320-400 Paul Avenue Data Center and associated Extension of PG&E 12kV Electrical Distribution Circuits

Final Preliminary Mitigated Negative Declaration
San Francisco Planning Department

MITIGATED NEGATIVE DECLARATION

Project Title: **320-400 Paul Avenue Internet Services Exchange (ISE)**

Figure 24 – Project-Level (without Mitigation Measure M-AQ-3) Excess Cancer Risk

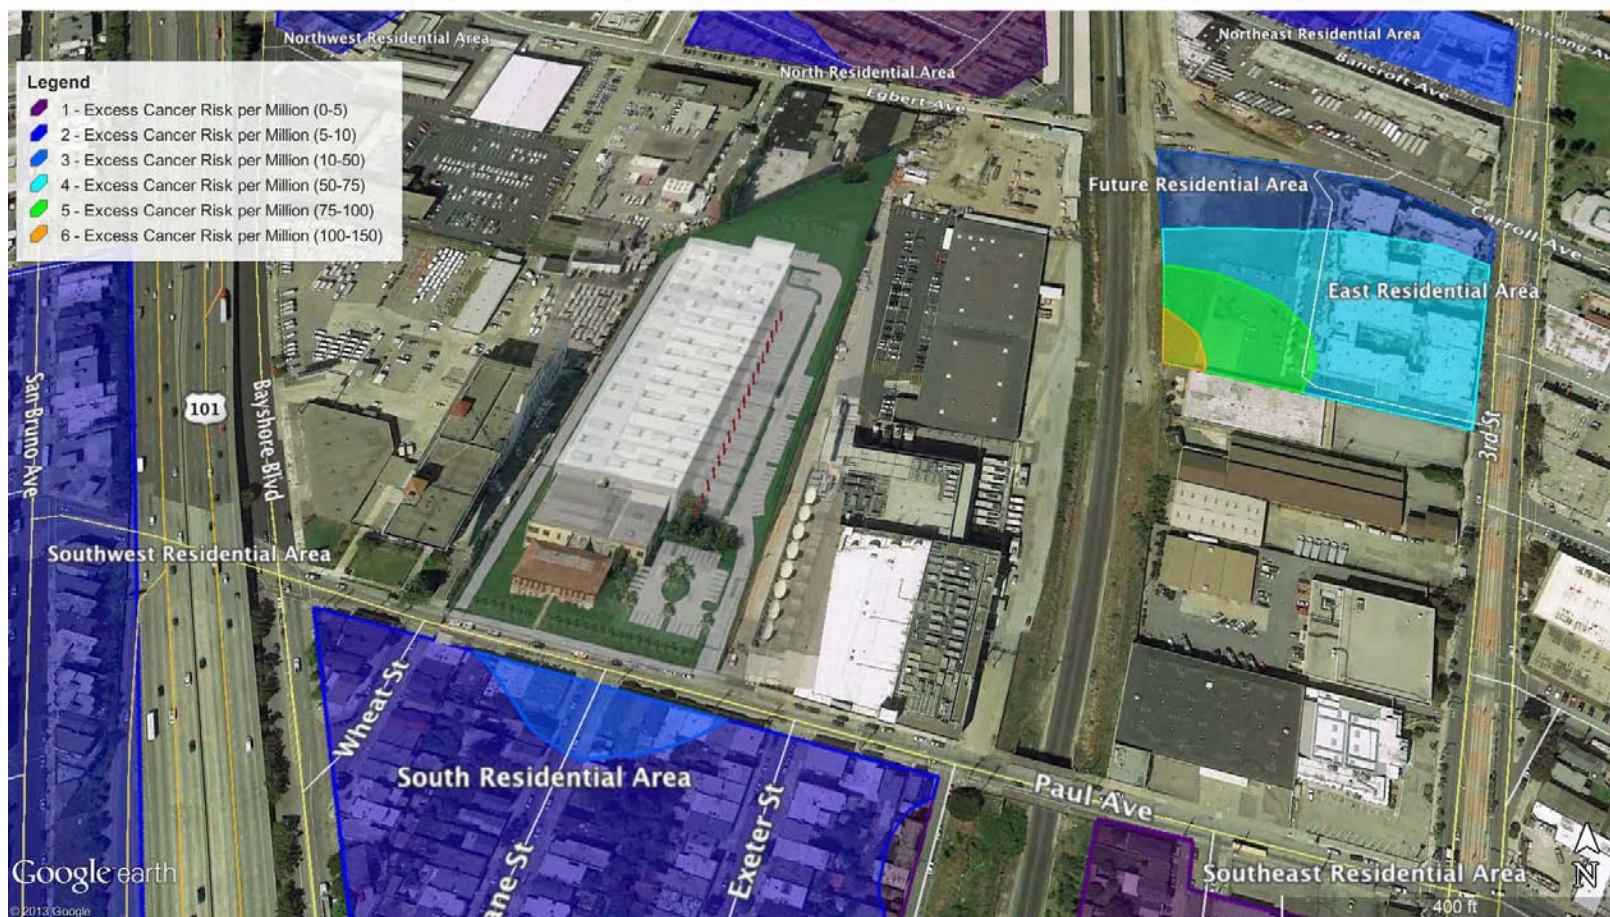
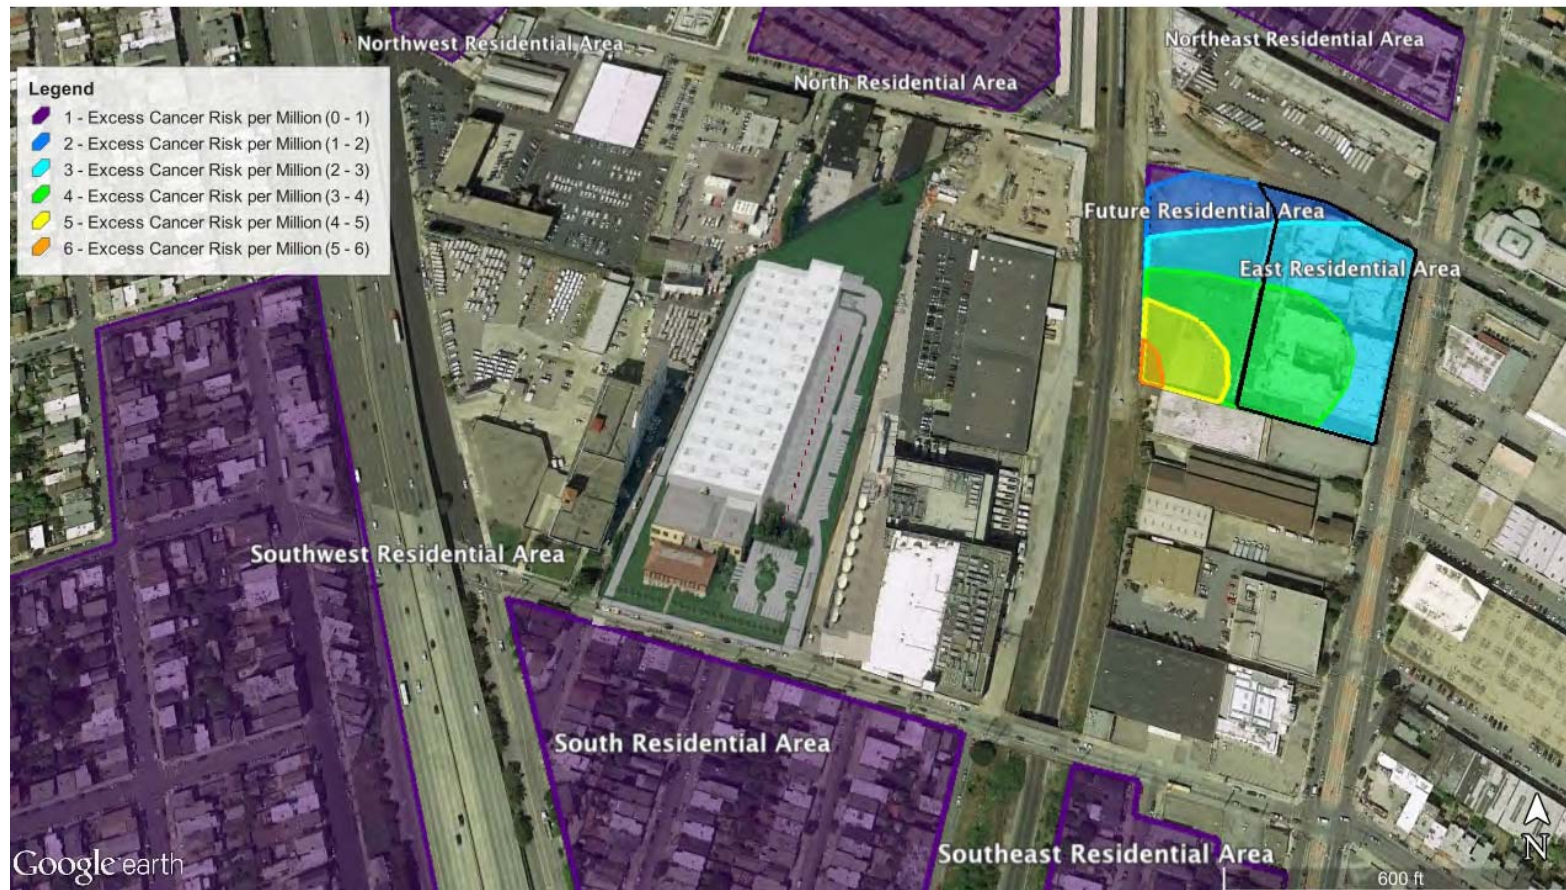
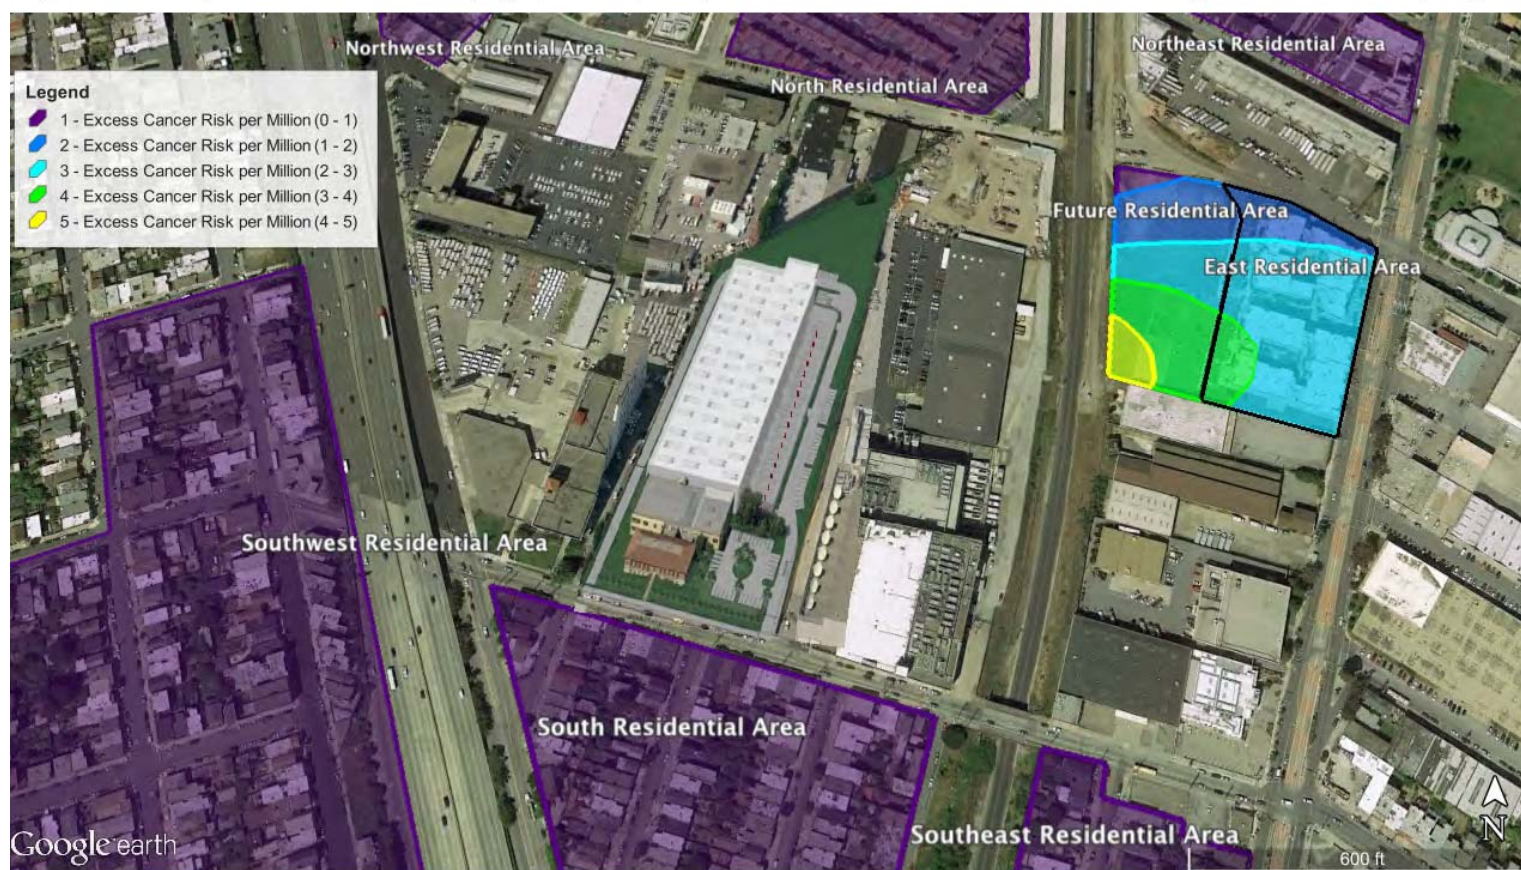
Taking these projections as true, the modeling and diagrams in Figures 24-26 (pages 125-127) call into serious question the project sponsor's decision to locate the diesel generators on the easterly side of the building. The depictions in Figures 24-26 (and the basic science behind particulate dispersion) dictate that every foot of added distance between an emission source and receptor site matters, that is, the farther away one is from the emission source the lesser the adverse impacts from exposure to that source. Given that the Project site is bounded to the west by the U-Haul facility at 500 Paul Avenue and to the east by another ISE at 200 Paul Avenue, and that prevailing winds in this area consistently travel west to east (from the upper elevations of McLaren Park to the Bay), the most appropriate siting for the diesel generators is the west side of the building closest to 500 Paul

Taking these projections as true, the modeling and diagrams in Figures 24-26 (pages 125-127) call into serious question the project sponsor’s decision to locate the diesel generators on the easterly side of the building. The depictions in Figures 24-26 (and the basic science behind particulate dispersion) dictate that every foot of added distance between an emission source and receptor site matters, that is, the farther away one is from the emission source the lesser the adverse impacts from exposure to that source. Given that the Project site is bounded to the west by the U-Haul facility at 500 Paul Avenue and to the east by another ISE at 200 Paul Avenue, and that prevailing winds in this area consistently travel west to east (from the upper elevations of McLaren Park to the Bay), the most appropriate siting for the diesel generators is the west side of the building closest to 500 Paul Avenue – not on the east side of the building as currently designated.
